# Better Barnsley Town Centre

## - Midland Street and Interchange Square Design Development

### Design And Access Statement

The purpose of this report is to highlight the key design development changes that have occurred to Midland Street and Interchange Square and the reason for those amendments.

### Urban Planning Officer Comments

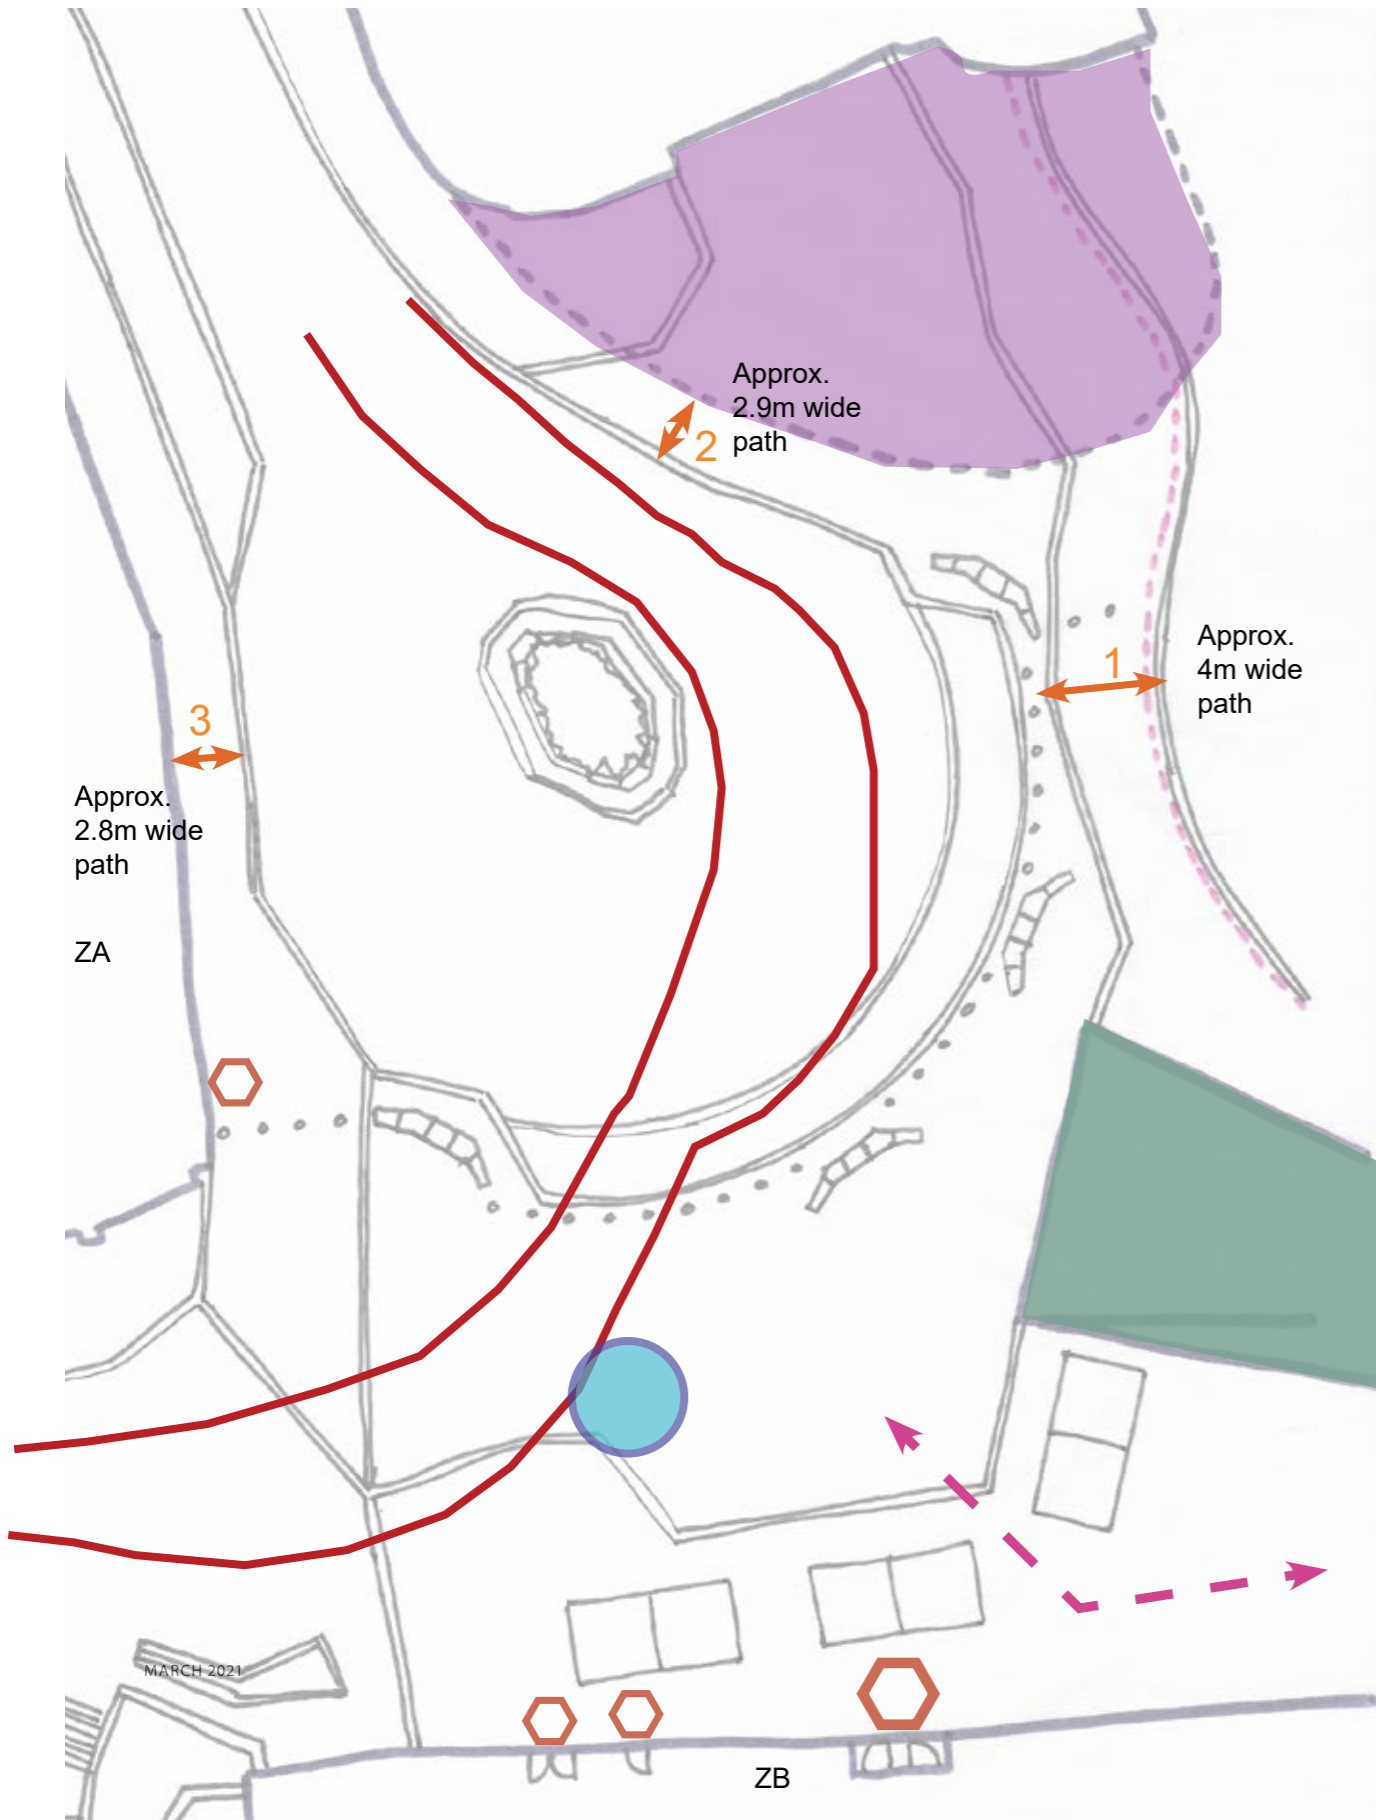
In summary my concerns were that the proposals for Interchange Square and for the area where the fish and chip shop on Eldon Street had been demolished were just empty, desolate spaces. They were not welcoming spaces for pedestrians and not up to the pedestrian-friendly standards of the rest of the Glass Works/ town centre public realm proposals. These areas form part of the first impressions of the regenerated town centre, (from the western exit of the Interchange, from the southern exit of the Interchange, from across the new pedestrian bridge and for passengers disembarking at the taxi rank), but they just seem to be characterless, 'leftover' spaces, dominated mainly by highways and then, secondly, by empty paving. The mining artwork and the pedestrian bridge appear to be left desolate in this featureless setting. I reminded them that the rest of the Glass Works scheme had been winning awards and so it was important that these two areas felt joined-up and integrated with the rest of the scheme- not appearing as 'weak' links.

Among my suggestions were to add more trees into Interchange Square, (even if they had to be in planters due to underground service restraints), to help guide pedestrians to walk more safely in the direction of the adjoining, main public square, (rather than straight across the taxi rank/ servicing area in the centre of Interchange Square), to help soften and alleviate the base of the 'cliff-like' side elevation of the cinema, to provide a better setting for the mining artwork, (so it's not just surrounded by blank, empty paving when it's a non-market day and the temporary market stalls are not there), and to provide a better setting for the pedestrian bridge.

I also suggested that they re-look at the arrangement of the yorkstone paving so that it guides pedestrians leaving the southern exit of the Interchange more strongly along the side of the square and into the adjoining, main public square, (rather than guide them across the taxi rank/ service road in the centre of Interchange Square).

For the area left by the demolition of the fish and chip shop on Eldon Street I said that when this demolition was first mooted we were informed that it was proposed to provide a more welcoming gateway feature into Barnsley from this western exit of Interchange. However, from the current layout plan all that seems to have occurred is that a new left hand turn of highway has been provided out of Midland Street and then the rest of the new area will just be left as a big, empty space. Carl explained that Andrew Osborn thought that there was a possibility that in the future the buildings of the covered arcade, (linking the Interchange/ Midland Street to Eldon Street), may be redeveloped and so didn't want to make changes to this space which could then have to be redone. I responded that even putting some trees in planters as a temporary solution was better than leaving it as a big, empty space.

I said that if this public realm plan for Midland Street was put in front of the design panel, (the proposals for the Glass Works scheme has been to a total of eight design panels in the past), I did not think they would receive the proposals very well.

[Please see following pages with supporting information, illustrations and explanations provided to help with the above queries.](#)
